CITY COUNCIL REGULAR MEETING

City Council Chambers, 33 East Broadway Avenue Meridian, Idaho
Tuesday, April 02, 2024 at 6:00 PM

HEARING DATE: 4/2/2024
 TO: Mayor & City Council
 FROM: Sonya Allen, Associate Planner
 208-884-5533
 SUBJECT: SHP-2024-0001
 Watts Meridian Medical Partners
 LOCATION: 1256 S. Rackham Way, in the SW 1/4 of
 Section 16, T.3N., R.1E. (Parcel
 #R6819240215)

STAFF REPORT	
COMMUNITY DEVELOPMENT DEPARTMENT

D. Common Drive Exhibit —NOT APPROVED

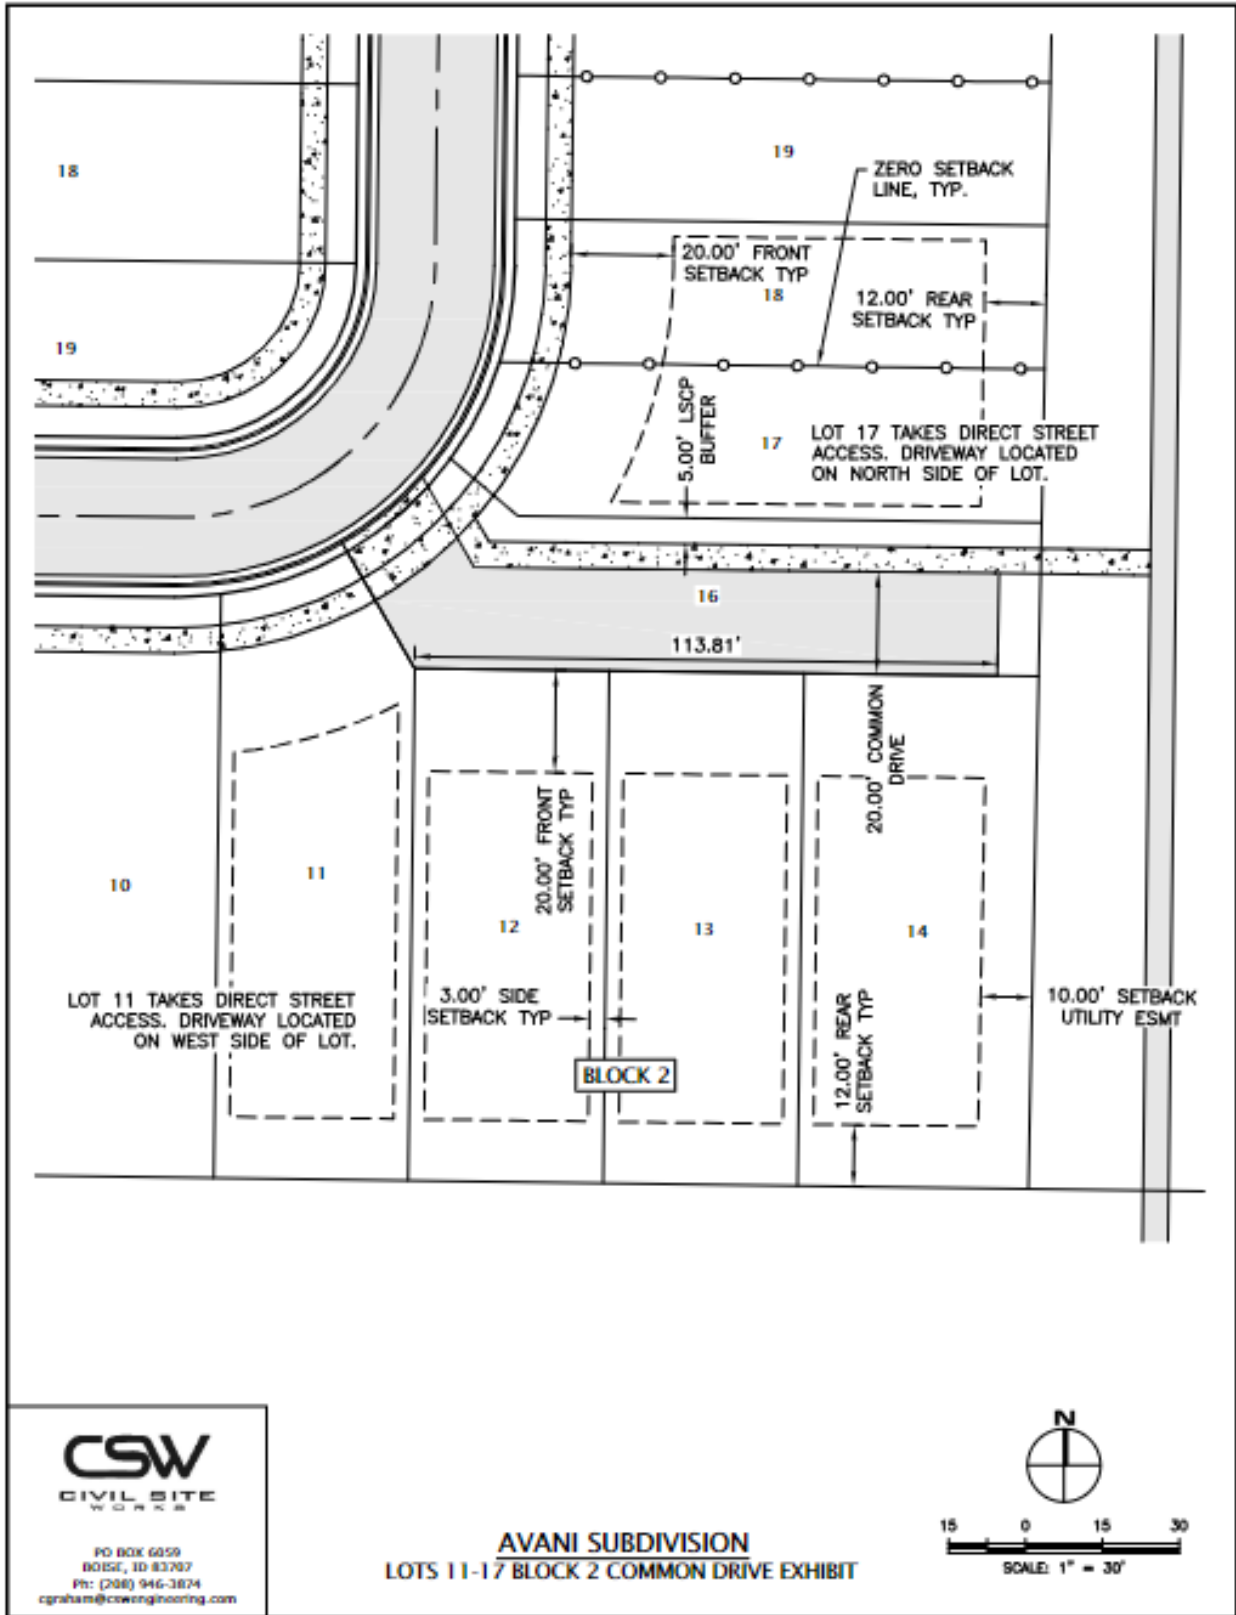
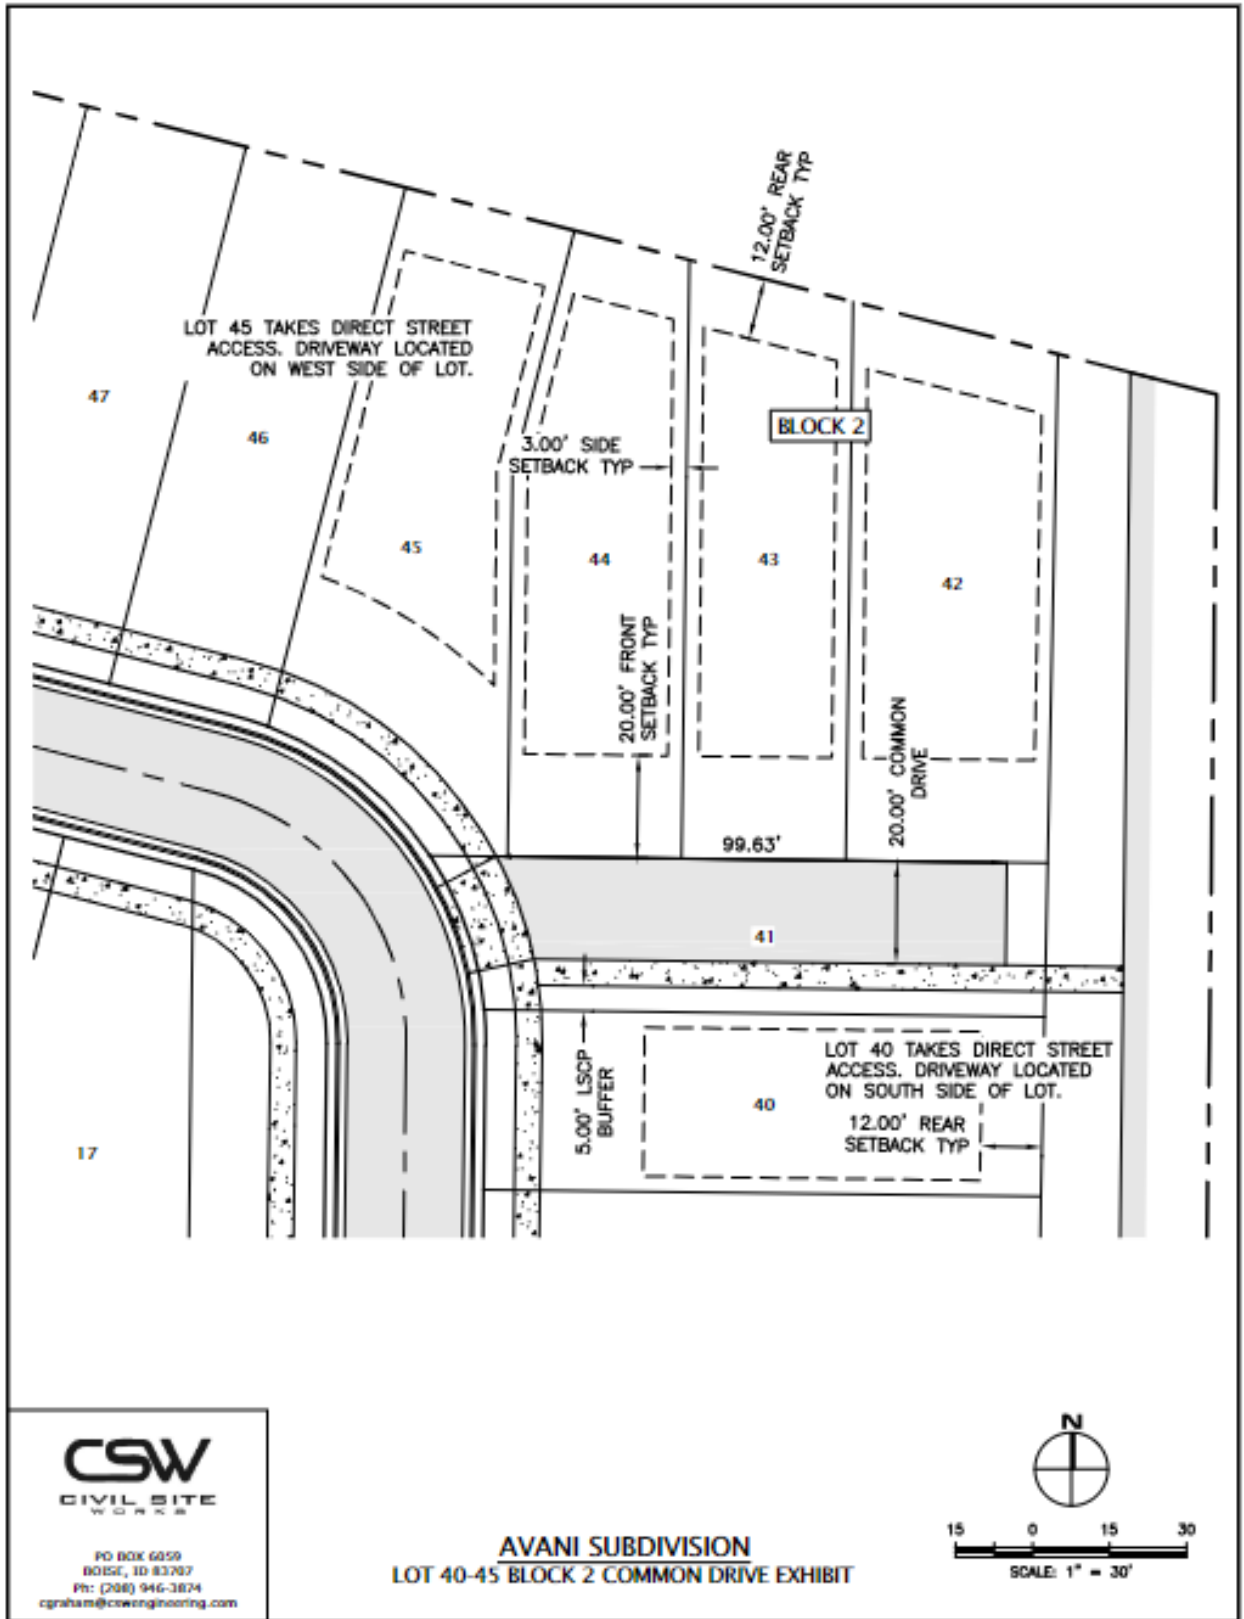
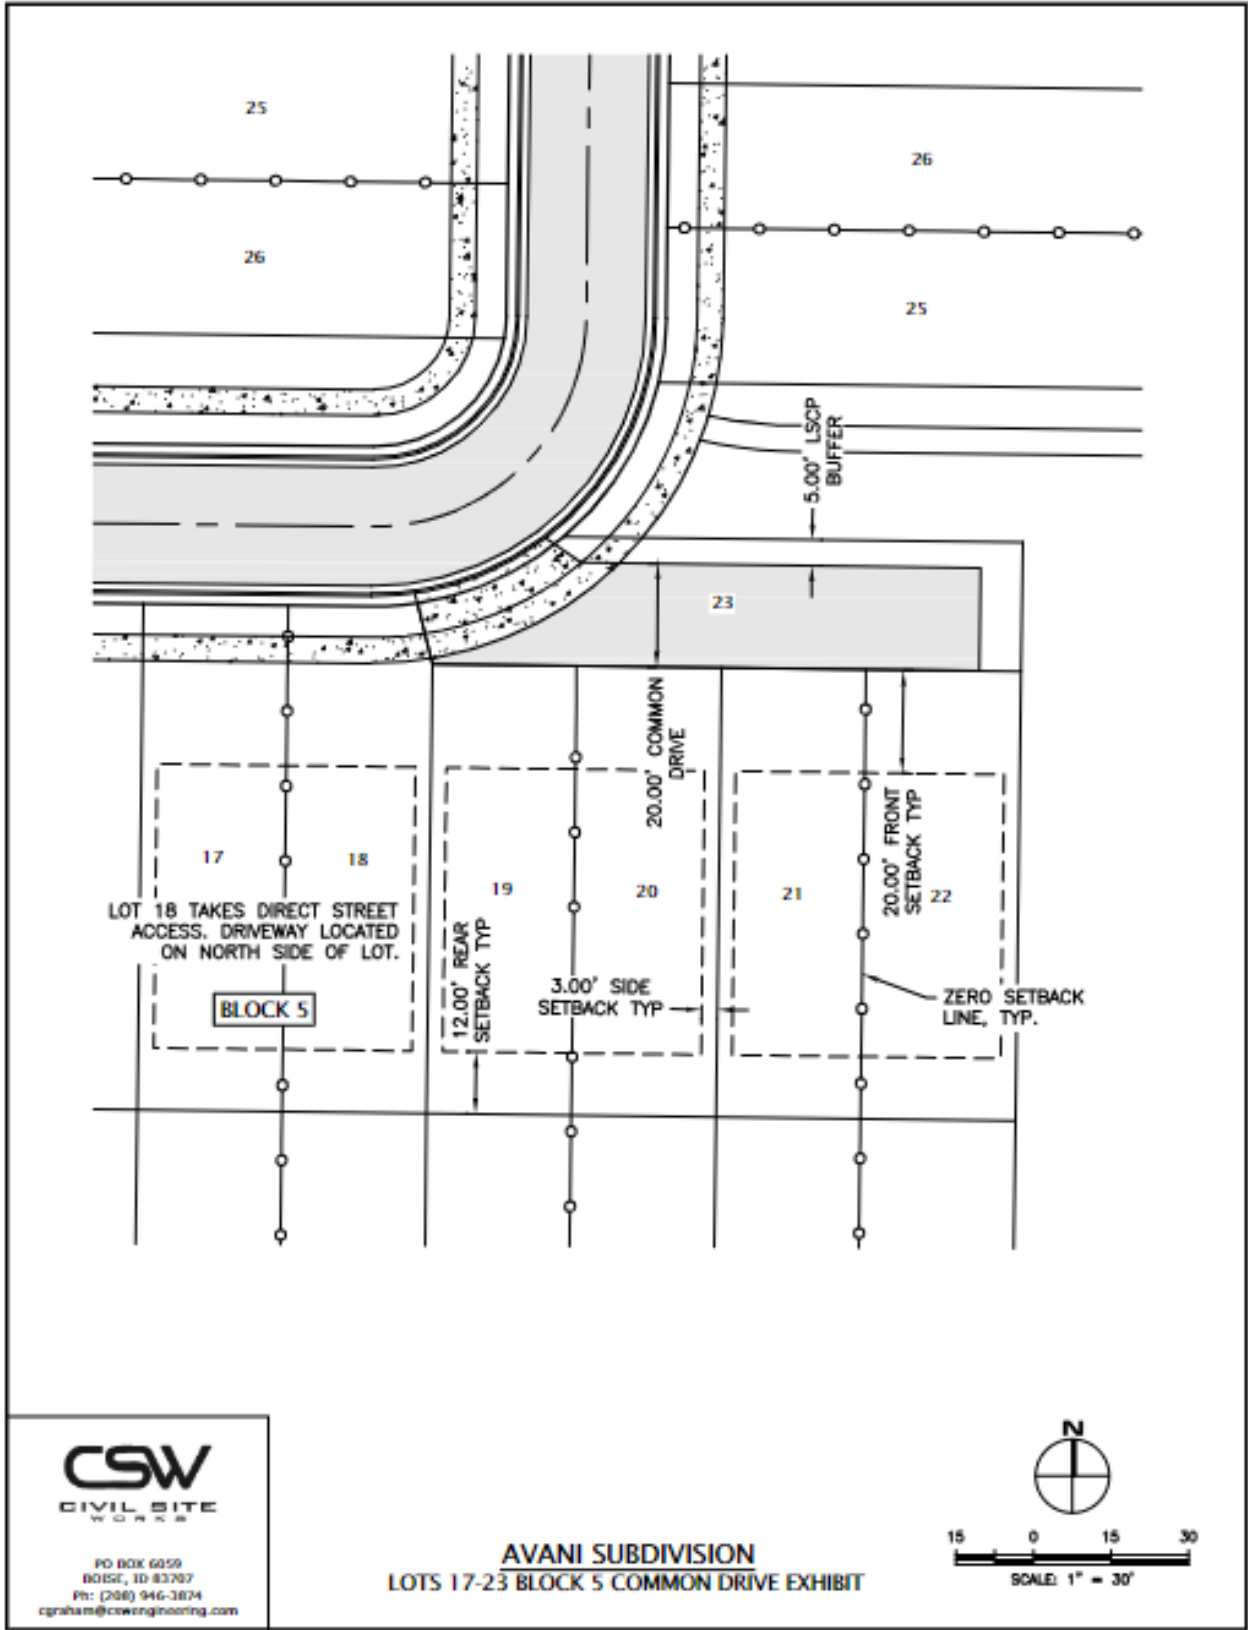
Common Driveway (UDC [11-6C-3D](#)): Six (6) common driveways are proposed within the development of the site on Lot 42, Block 1, Lot 16, Block 1, Lot 41, Block 2, Lot 33, Block 2, Lot 16, Block, 2, and Lot 23, Block 5. Common driveways are allowed to serve a maximum of four (4) dwelling units; in no case shall more than three (3) dwelling units be located on one (1) side of the driveway. **A total of four (4) dwelling units are proposed on the south side of driveway for Lot 23, Block 5; the final plat and common driveway exhibit shall be revised to depict a maximum of three (3) units on one (1) side of the driveway as required; or, alternative compliance may be requested as set forth in UDC [11-5B-5](#).**

5. The common driveway shall be designed and constructed per the standards listed in UDC [11-6C-3D](#). **Revise the common driveway exhibit in Section VIII.C to reflect a maximum of three (3) dwelling units on one (1) side of the driveway as set forth in UDC 11-6C-3D.1; or, alternative compliance may be requested as set forth in UDC [11-5B-5](#).**

E. Landscape Plan – Preliminary Plat (dated: 10/19/2023) — *NOT APPROVED*

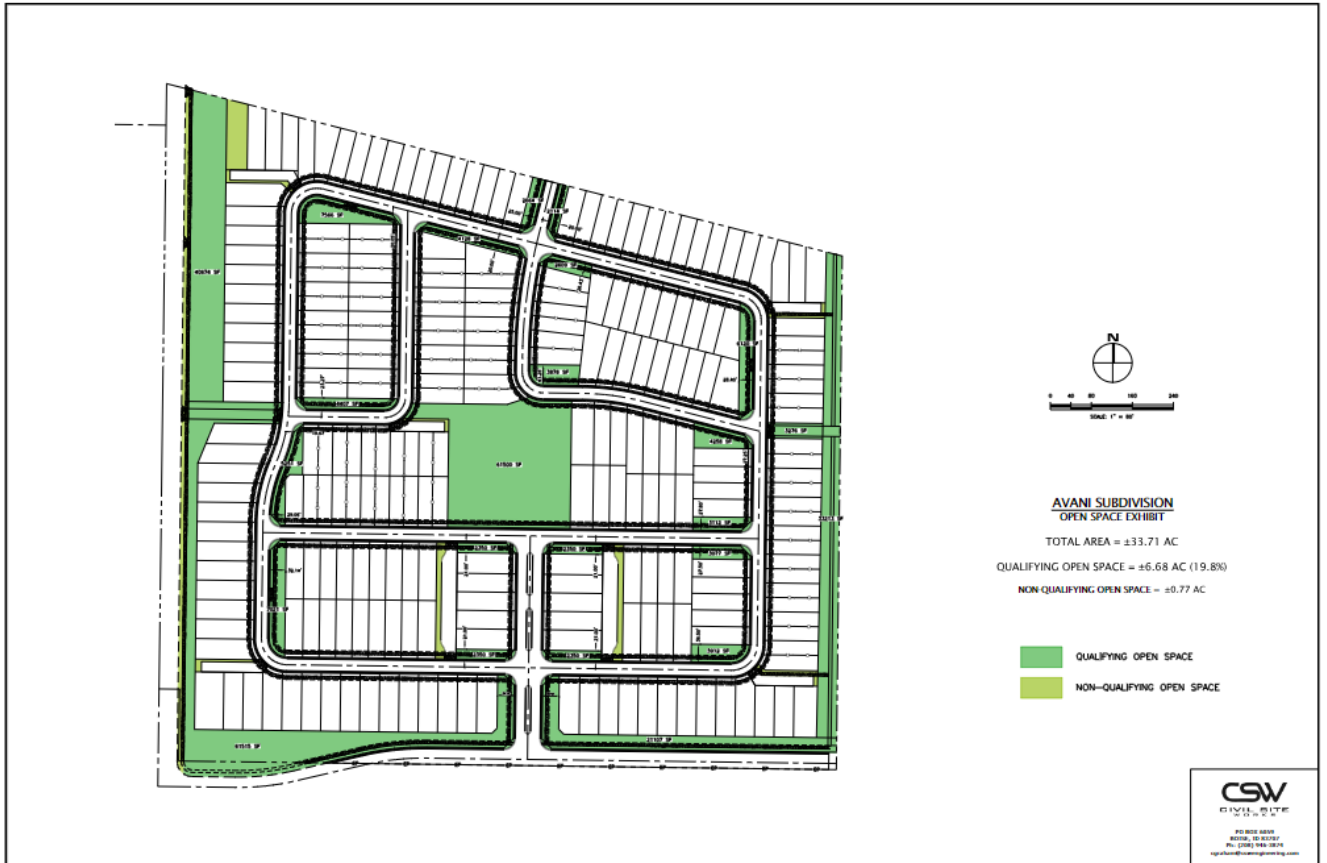
There are several existing trees on the south side of this site that will be removed with development. An existing tree inventory and mitigation plan is not included in Section VIII.H. **Mitigation is required to be provided per the standards listed in UDC [11-3B-10C.5](#); calculations demonstrating compliance should be included on the landscape plan submitted with the final plat application.**

- a. Revise the landscape plan consistent with the changes to the final plat listed above.
 - b. Include mitigation calculations on the plan for existing trees that are proposed to be removed in accordance with the standards listed in UDC [11-3B-10C.5](#) and the exhibit in Section VIII.E.
